Rezoning Transportation Analysis

Petition Number: 2020-112

General Location Identifier: 04711109

Revision Log:

FIGURE 1 & 2: Recommended Street cross-sections

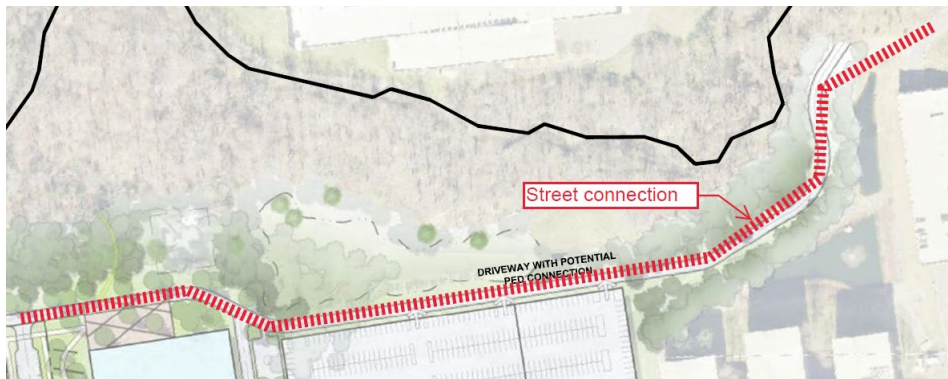
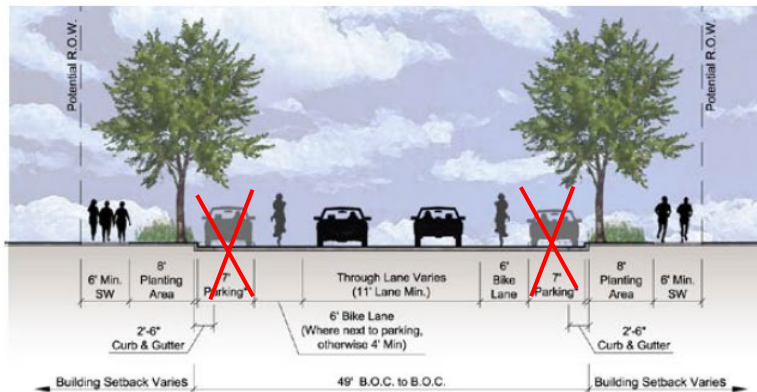
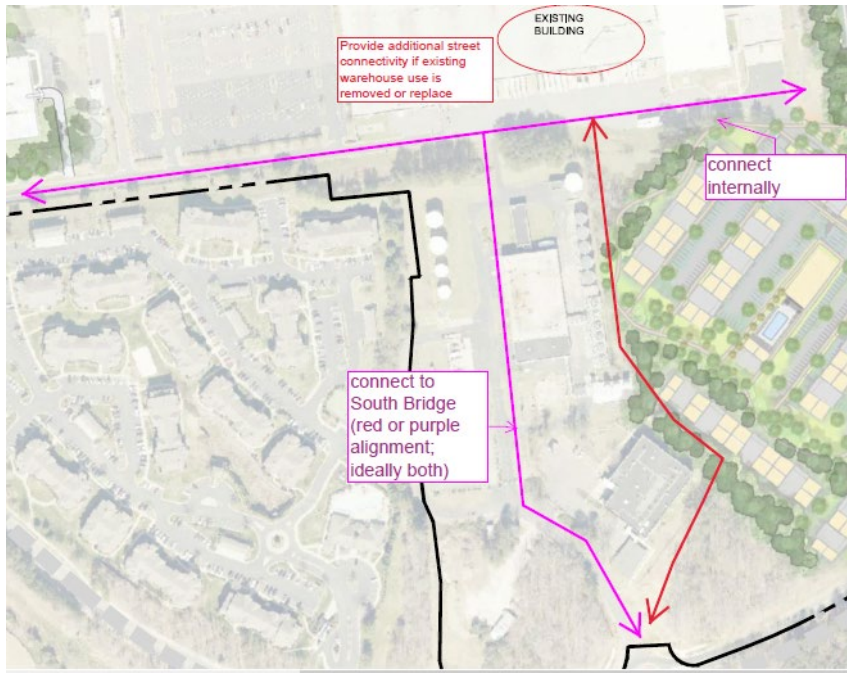
5. **Outstanding (Site plan dated 8/16/21):** Revise "Proposed Public Road D" cross-section to include a 6' bike lane. The site plan and conditional note(s) need to establish a street connection, as shown below, according to the proposed avenue cross-section that is recommended within the University Research Park Area Plan. Refer to pages 38 and 41.

- 49-foot Back of Curb to Back of Curb
Min. 77-foot right-of-way
- 6-foot Sidewalk: Improved pedestrian realm, compliant with ADA (Americans with Disabilities Act)
- Bike Lane: 4-foot Min, 6-foot where on street parking is present - safer bicyclists realm, improved truck turning radius, additional buffer for pedestrians
- Planting area: Buffer for pedestrians; beautification
- On street parking: additional buffer for pedestrians, shared parking, active streetscape
